City of
Richmond

Report to Development Permit Panel

File: DV 15-704583

Re: **Application by Matilde Abella for a Development Variance Permit at
10455 Bridgeport Road**

PLAN #1

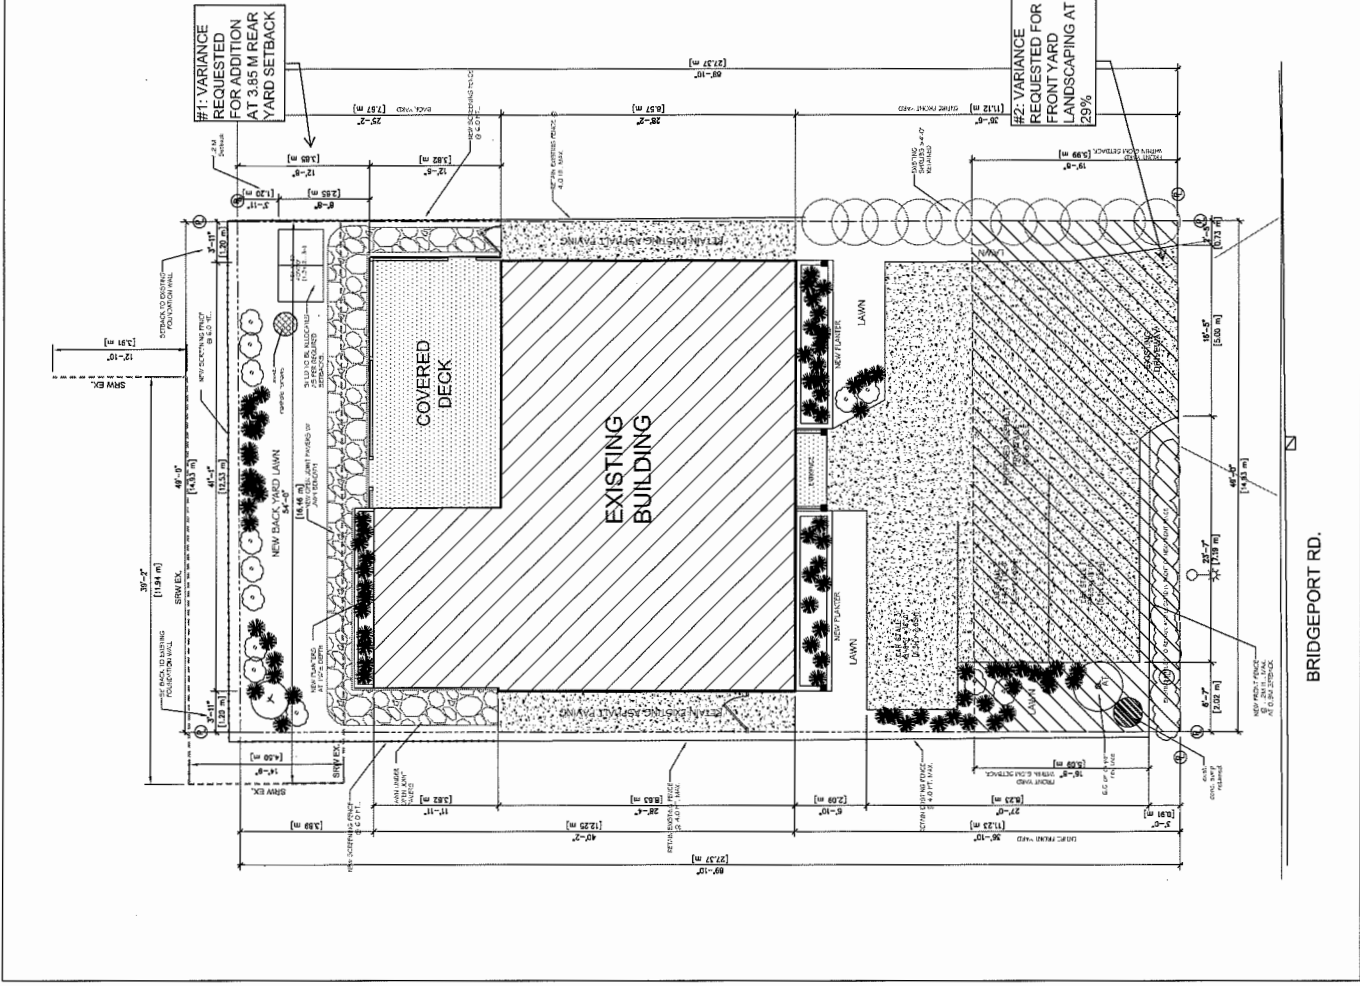
- The existing rear addition, which consists of an enclosed kitchen/dining area and a covered patio open to two sides, projects 2.15 m into the required rear yard setback of 6.0 m, providing a 3.85 m separation from the property line to the north (Plan #1).

- The Building Permit application to legitimize the existing construction also includes an application for a legal secondary suite. The subject lot is located on an arterial road (Bridgeport Road), which requires one vehicle parking space for the secondary suite, in addition to the two vehicle parking spaces required for the principal dwelling, for a total of three parking spaces.

- Due to the conversion of the carport into habitable space, the required off-site parking is proposed to be located in the driveway. Staff have worked with the applicant to design the concrete area in the driveway to accommodate the required vehicle parking spaces, provide sufficient space for vehicle turn-around on-site to prevent vehicles from backing out onto Bridgeport Road, and maximize landscaping.

1 LANDSCAPE PLAN
1/8" = 1'-0"

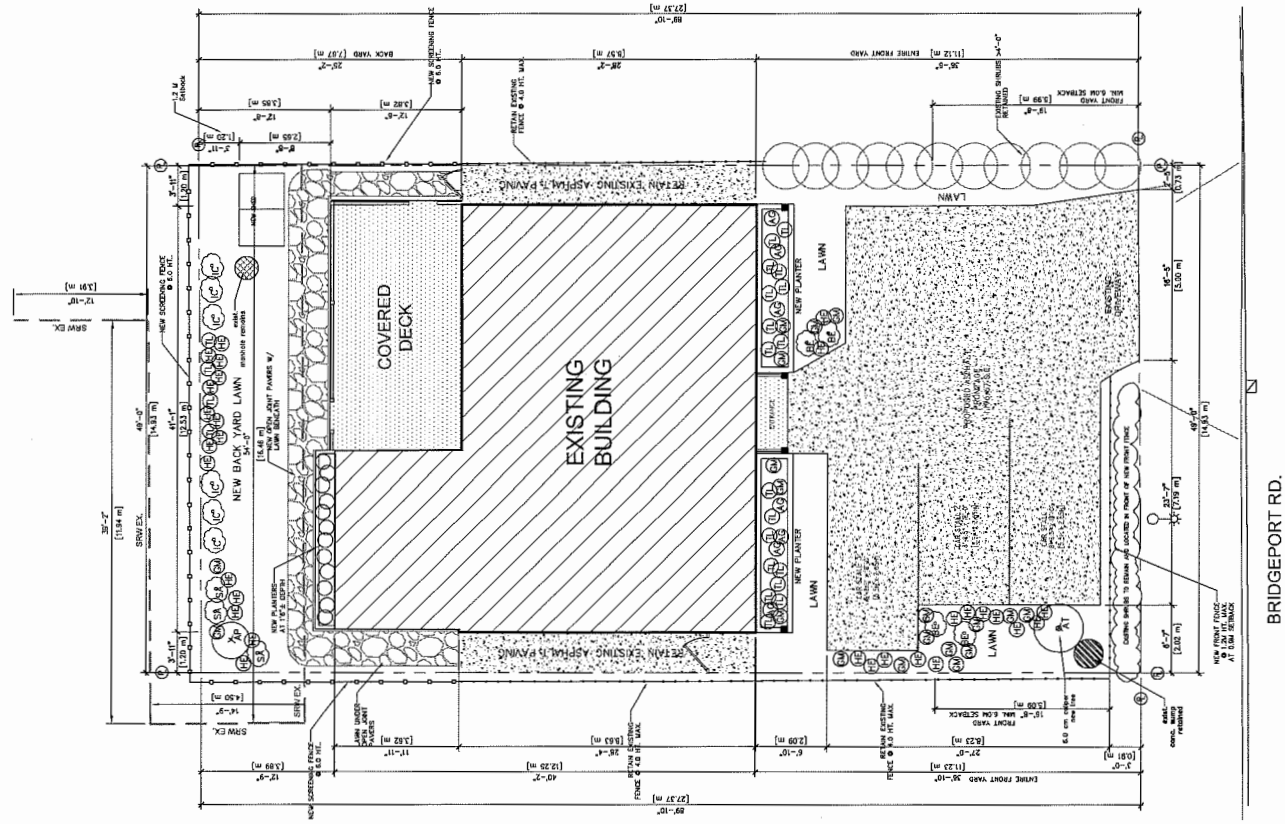
- Currently, approximately 1% of the lot coverage for the subject site is live landscaping. Staff have worked with the applicant to achieve the minimum lot coverage for live landscaping required in Zoning Bylaw 8500 (30%), as demonstrated in the submitted Landscape Plan (Plan #2).

- Included in the landscape plan, are the planting of two trees; one in the front yard and one in the rear yard, and a variety of shrubs, low-lying vegetation and grass. The proposal also includes removing portions of the existing concrete surface to increase the landscaped area on-site.

- A new 1.2 m (4 ft.) high fence along a portion of the front yard and a new 1.8 m (6 ft.) high fence along the rear yard are proposed to provide screening of the vehicle parking area and rear addition, and increase privacy between the adjacent neighbouring properties.
